ZONING CASE NUMBER: C814-2014-0120 – Austin Oaks PUD

ZONING CHANGE REVIEW SHEET

CASE: C814-2014-0120 – Austin Oaks Planned Unit Development

Exhibit H, Creek Plan

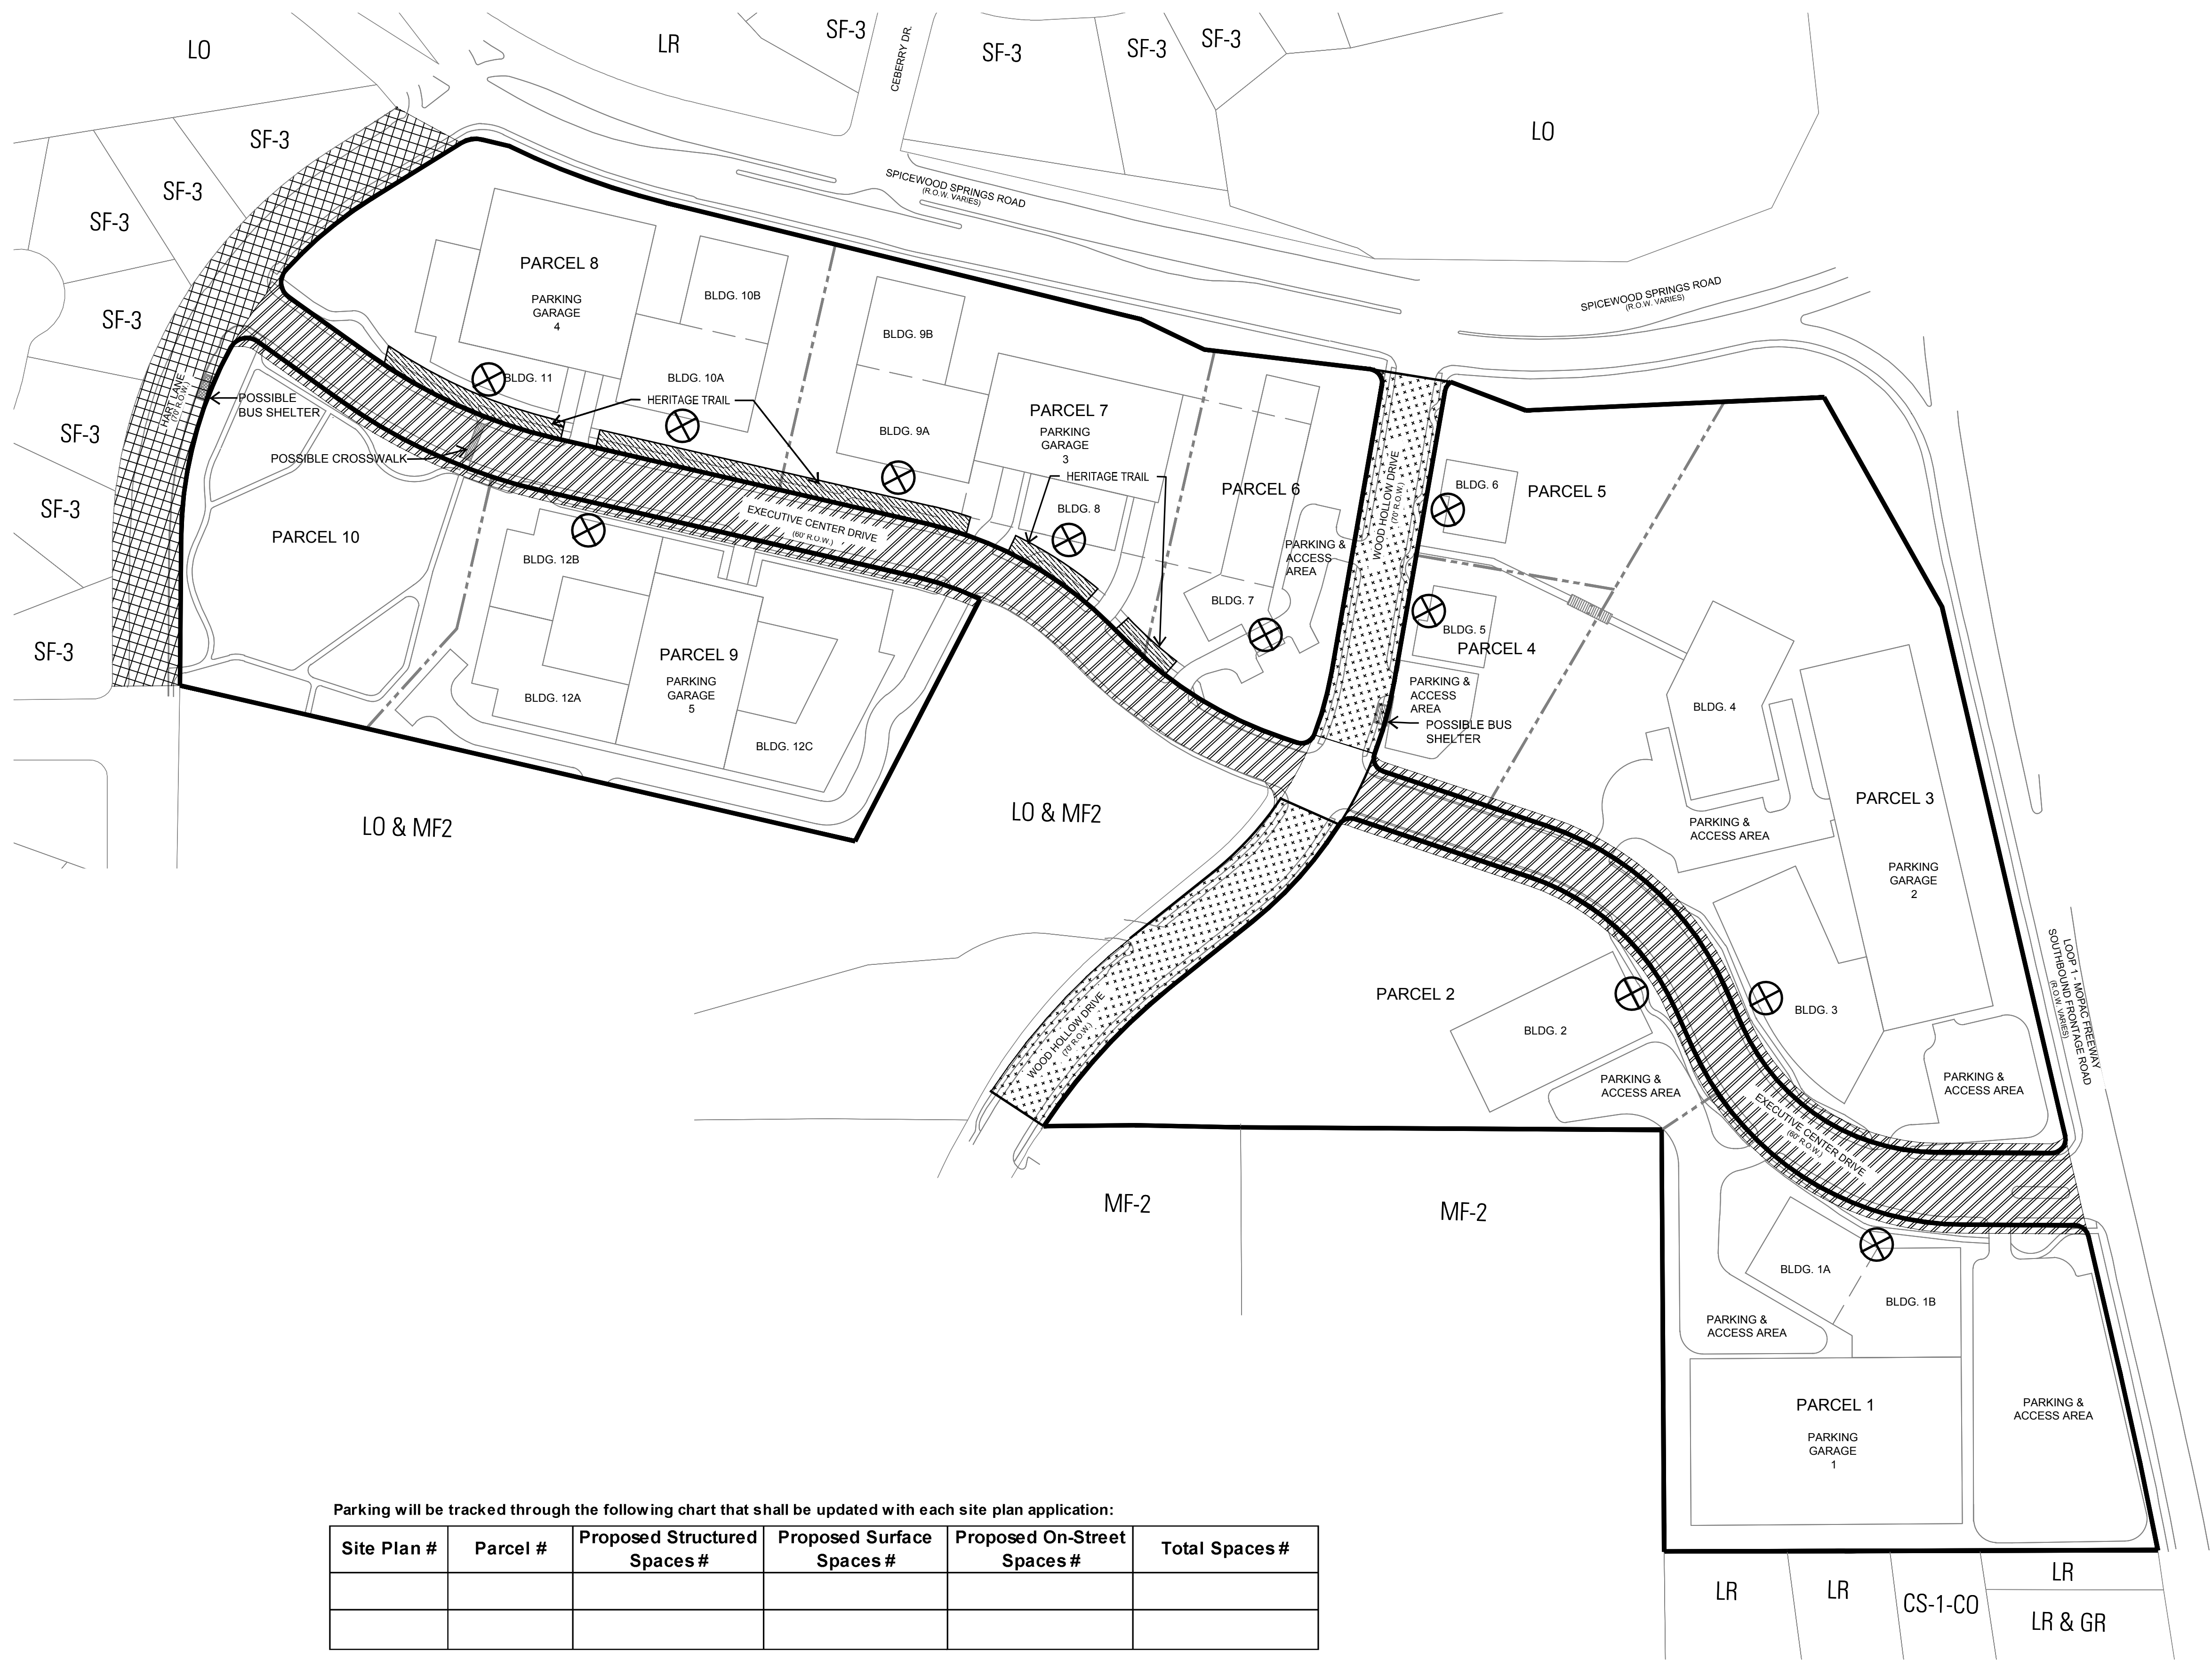
EO 17. As noted in EO [15], the boundaries on this exhibit are difficult to read. Please revise the symbology to better illustrate the environmental features and restoration areas, and remove any information that is not necessary for PUD review (e.g., EHZ, drainage easements, etc.).

Update 4: There are several places where the 100-year fully developed floodplain extends beyond the identified CWQZ. Please correct the CWQZ boundaries to follow the 100-year fully developed floodplain in areas where the floodplain width is between 50' and 400' from the creek centerline. (Maintain a minimum CWQZ width of 50' where the floodplain is narrower than 50' from centerline.)

EO 18. Please delete notes 1, 2, and 5, and delete or revise notes 3, 4, and 6 to reflect requested changes to the superiority table. All significant elements of the PUD proposal should be included in either the superiority table or a code modification table. Notes on the exhibit can repeat,

Update 4: Update the restoration language in Note 2 to match the staff suggestion above. Please add a note specifying that the proposed pedestrian bridge must span the erosion hazard zone with one set of piers within the creek channel if necessary.

Note 2 and the restoration language suggested above only apply to areas within the CWQZ and CEF buffer. There are some areas where impervious cover will be removed that are outside of the CWQZ and CEF buffer. Staff suggests specifying that areas outside of the CWQZ and CEF buffer will be planted and seeded pursuant to Standard Specification 609S, but that those areas do not need to achieve a score of “Good” under the floodplain modification parameters.

Update 5: Comment cleared.
